## REMARKS

### The Rejection of Claims 1, 9, 13, 14, 17, 25, 29 and 30 under 35 U.S.C. 102(b)

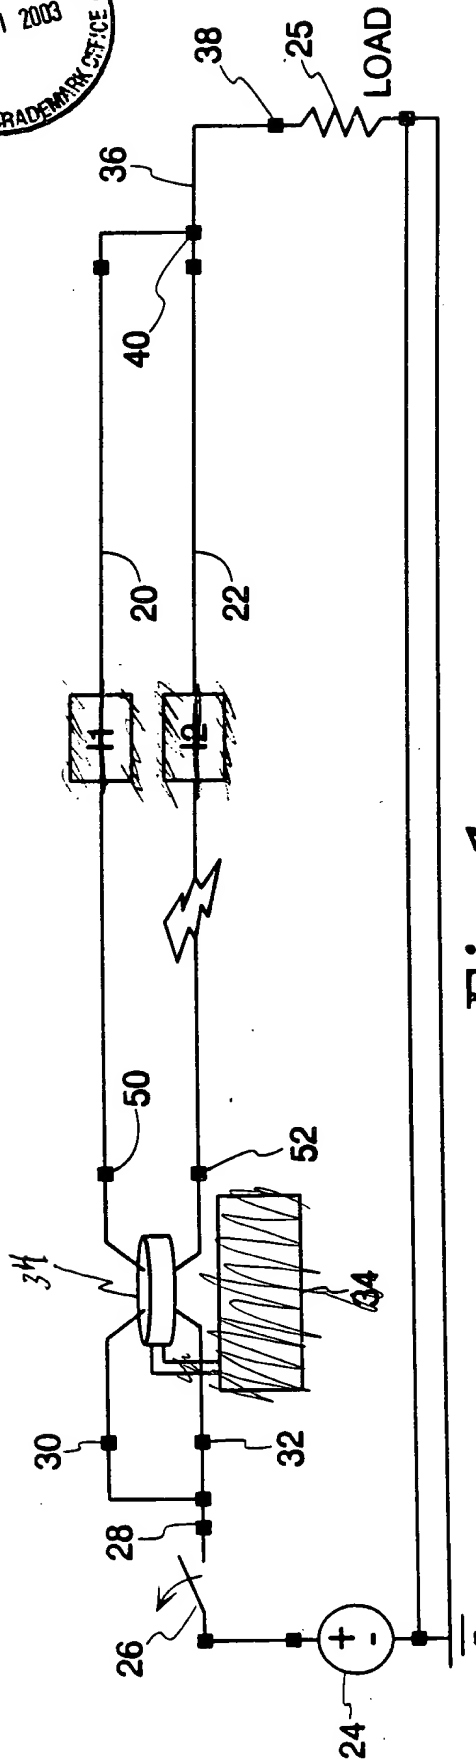
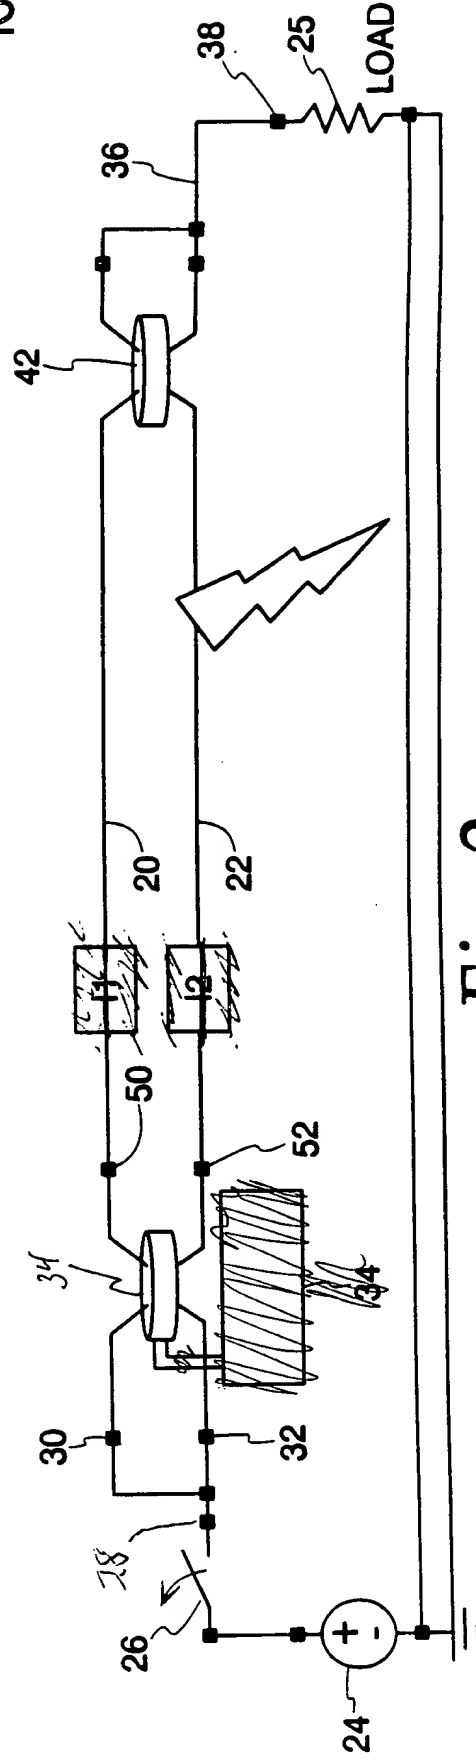
The Examiner objected to the drawings because they did not have sufficient labels; specifically boxes 34, 34A, 43 and 35 were cited. The blank boxes in the drawing have been descriptively labeled in the proposed drawing amendments submitted herewith.
